NEW CONSTRUCTION FOR:
CORNERSTONE DESIGN BUILD LLC
6265 Vessey Rd, Colorado Springs, CO 80908

NO.	DESCRIPTION	DATE
REVISIONS:	PERMIT SET	10/16/2026

SITE PLAN — A01

1 A01 **SITE PLAN** 1" = 20'-0"

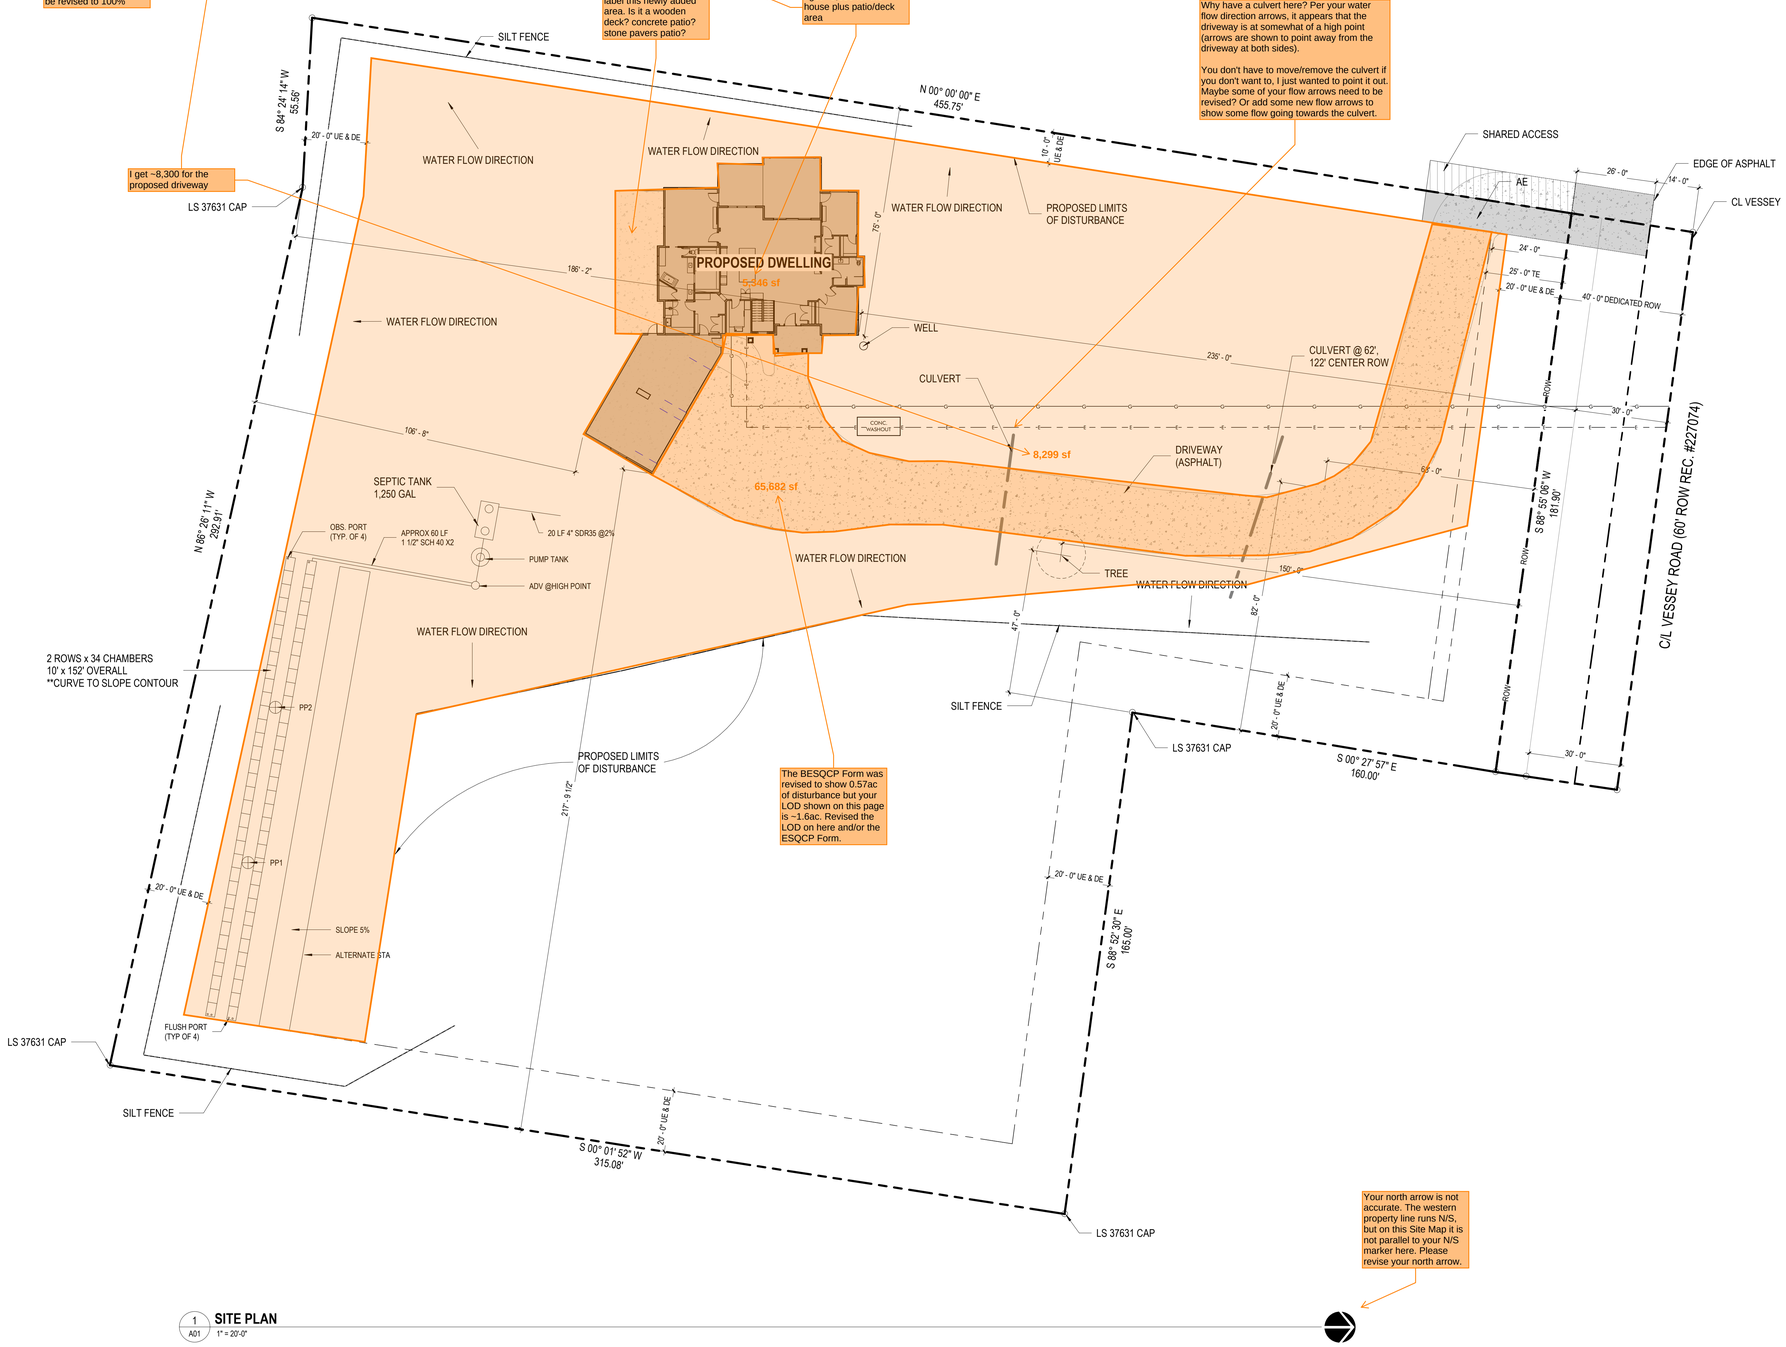
From aerial imagery from Aug 2026, there is no structures shown on this parcel. Has a house, detached structures, and a driveway been constructed between 8/1/26 and now? If not, all inputted Existing Areas should be 0 sq ft.

Per the accessor's page (linked below), this parcel is 2.8ac which is 121,968 sq ft. So please revise this. I am not trying to nit-pick you over 0.3ac, but trying to help you because if the total impervious area is >10%, then you have to do an Infiltration Study, which is obviously more work that you don't want to have to do.

the proposed driveway is asphalt, so this should be revised to 100%

I get ~5,350 for the house plus patio/deck area

label this newly added area. Is it a wooden deck? concrete patio? stone pavers patio?

I get ~8,300 for the proposed driveway

Why have a culvert here? Per your water flow direction arrows, it appears that the driveway is at somewhat of a high point (arrows are shown to point away from the driveway at both sides).

You don't have to move/remove the culvert if you don't want to, I just wanted to point it out. Maybe some of your flow arrows need to be revised? Or add some new flow arrows to show some flow going towards the culvert.

The BESQCP Form was revised to show 0.57ac of disturbance but your LOD shown on this page is ~1.6ac. Revised the LOD on here and/or the ESQCP Form.

Your north arrow is not accurate. The western property line runs N/S, but on this Site Map it is not parallel to your N/S marker here. Please revise your north arrow.
